NCUTCD Proposal for Changes to the Manual on Uniform Traffic Control Devices

ITEM NUMBER: 20B-RW-01

TOPIC: Vertical Clearance of Large Signs

AFFECTED SECTIONS OF MUTCD: Section 2A.18, 19

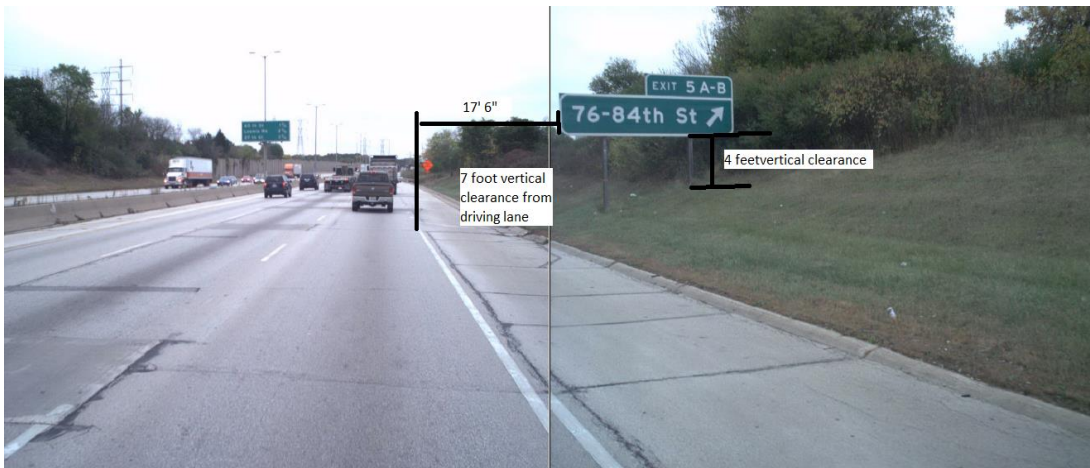
Paragraph 10 of Section 2A.18 requires directional signs on freeways and expressways to have a 7-foot vertical clearance from the near edge of pavement to the bottom of the sign. This

32 mounting height may be reduced to 5 feet if the sign is 30 feet or more from the edge of travel
33 way (see paragraph 09). This is reasonable and prudent.

34
35 Per paragraph 11 of Section 2A.18, for a large sign (defined as exceeding 50 square feet)
36 mounted on multiple posts, it is required that the clearance from the ground to the bottom of the
37 sign be 7-feet, which would include both the left and right corners of the sign. This language is
38 similar to the 2011 AASHTO Roadside Design Guide Section 4.3.2, which states that for “large
39 roadside sign supports” that “*The hinge should be at least 2.1 m [7 ft] above the ground so that*
40 *no portion of the sign or upper section of the support is likely to penetrate the windshield of an*
41 *impacting vehicle.*”

42
43 However, there are situations in areas of deep cut (generally urban or mountainous terrain) where
44 the lateral offset may be less than 30 feet due to right of way constraints. This then creates a
45 dilemma in that if the sign were to be placed at 7 foot vertical clearance measured from the
46 bottom of the far right corner (for a typical placement on the right side of the road), the resulting
47 mounting height above road could be 11 feet or more. This would require very long posts, in
48 turn requiring larger foundations to withstand design wind speed. An additional concern is that in
49 certain situations this could lead to the sign being mounted much higher than 7 feet above the
50 road, violating driver expectancy and reducing the reflected headlight retroreflectivity from
51 modern full-cutoff headlights.

183 **Figure 2A-2 Examples of Heights and Lateral Locations of Sign Installations**

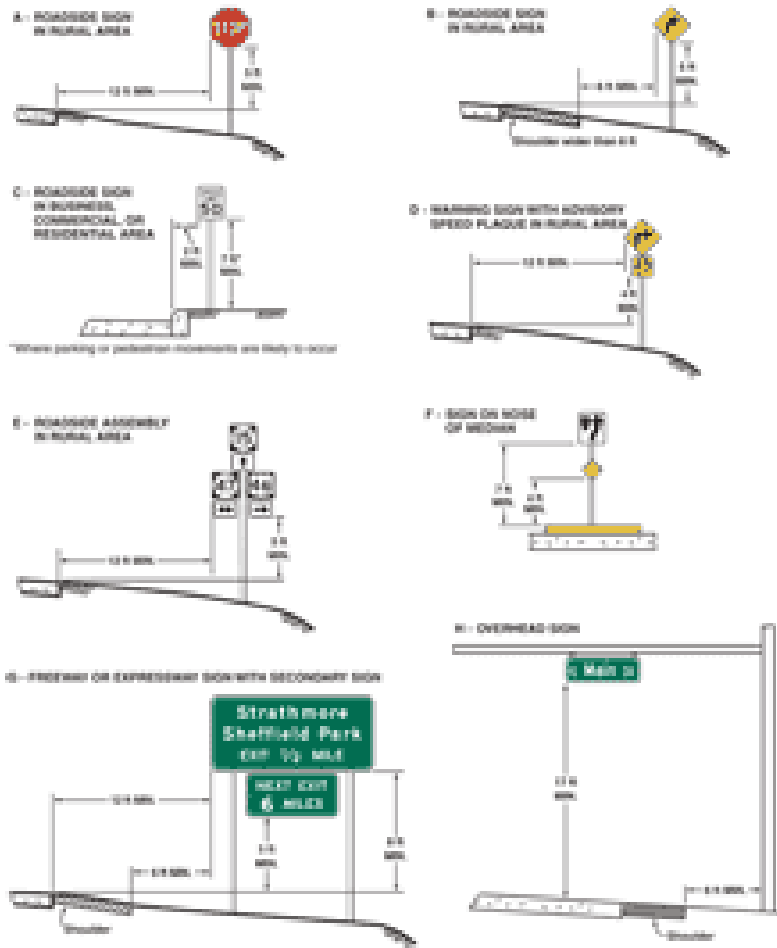
158 Support:
159 17 Figure 2A-2 illustrates some examples of the mounting height requirements contained in this
160 Section.
